## State of New Mexico ENVIRONMENT DEPARTMEN

RE: Administrative Completeness Determination and Issuance of Revised Permit
WIPP Hazardous Waste Facility Permit
EPA I.D. Number NM4890139088

NMED has issued a revised version of the Permit to reflect all modifications approved to date. These modifications include following:

The approved modifications are incorporated in Attachment 1, which contains the redline/strikeout pages of the modified permit to help the reader rapidly identify each modification. Language deleted from the permit is stricken out. Language added to the permit is highlighted in redline. For purposes of version control, NMED has established the date of these modified pages and attachments as January 30, 2003.

Figure B1-1 Headspace Gas Drum Age Criteria Sampling Scenario Selection Process

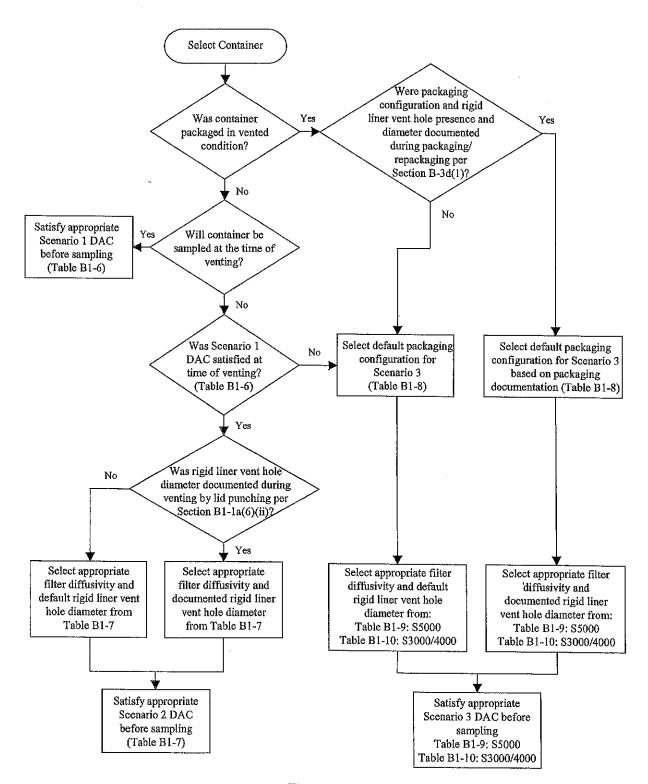
- designated as summary category S5000 (Debris waste) shall be categorized under one of the
- sampling scenarios shown in Table B1-5 and depicted in Figure B1-1. If the container is

- 33 Specific headspace-gas sampling steps to ensure samples are representative include:
  - Selection of the correct DAC Scenario and waste packaging configuration and meeting DAC equilibrium times.
